## **Starkweather Creek/Olbrich Gardens and Upper Badger Mill Creek Watershed Study RFP Questions City of Madison, WI**

Questions received by: 4:00 pm January 6<sup>th</sup>, 2021

Answers posted by: 4:00 pm January 8<sup>th</sup>, 2021

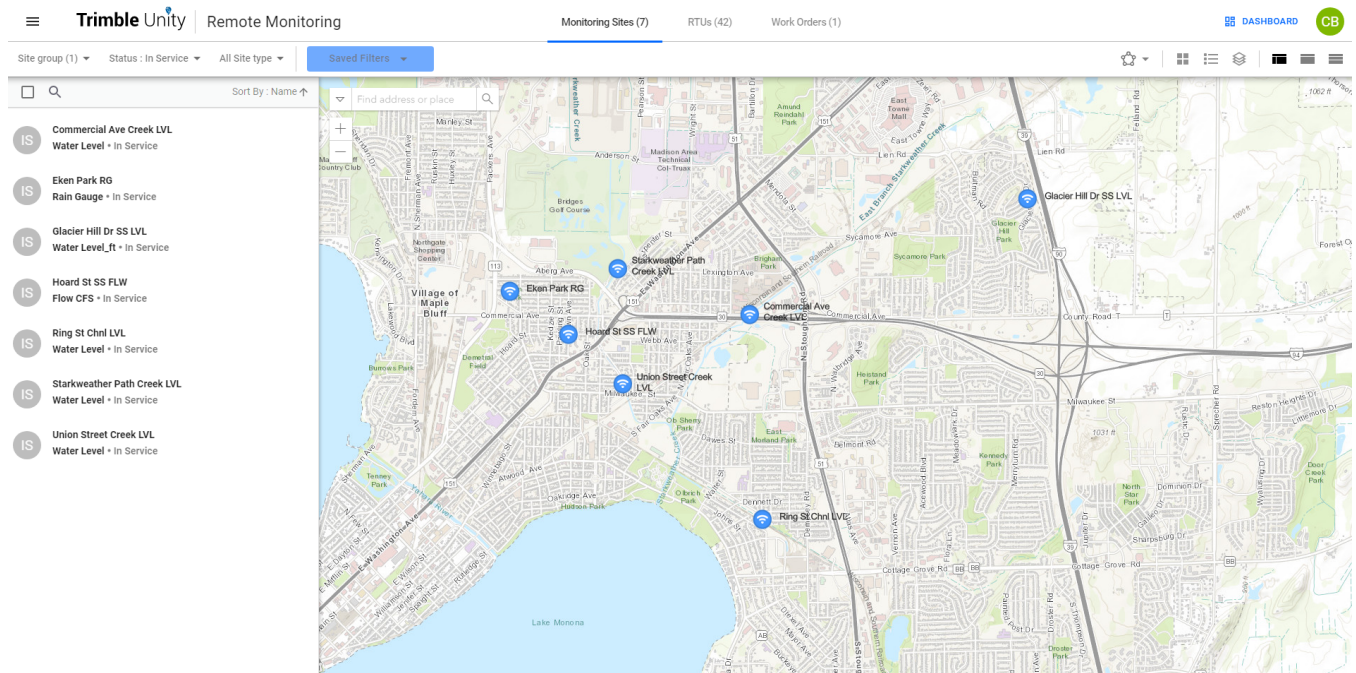
2. What are the number and types of USGS monitoring sites in the watershed?

How many monitoring locations are there within the Starkweather Watershed? What type of information is being collected at each location?

*Currently there are no USGS monitoring sites in the watershed. The City is working on an agreement to install USGS gages and they could be installed in 2021. Consultants will have access to this data if the USGS gages are installed.*

*There are 6 City gages (gages that the City has installed with the help of the USGS, but are not as robust as a typical USGS-gaging system). They have been placed in areas where backwater is not an issue (as much as possible).*

*Five of the City gages are level gages and one is a flow gage.*

*A screen capture of the gage locations from the Trimble Unity site (which the selected consultant will receive access to) is shown below:*
